Tractor Reflective Devices (WST172)

January 24, 2020

Effective: Chassis Starts on March 2, 2020

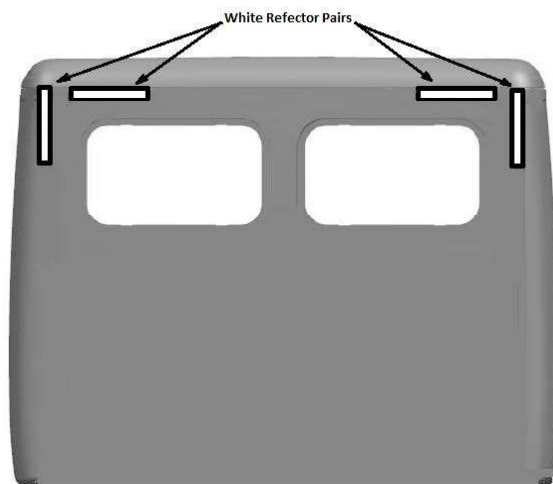
Our supplier communicated intent to stop production for the plastic reflex reflector (24-00816-000 CONSPICUITY STRIP) often used in two pairs to create the L-shaped white reflectors at the upper corners of the aft-facing surfaces of the cab/sleeper on tractors.

Effective with chassis starts noted, white retroreflective tape will replace all instances of the plastic reflector; the retroreflective tape will be used to create the two L-shaped white reflectors required by 49 CFR Part 571.108 (FMVSS 108) for tractors.
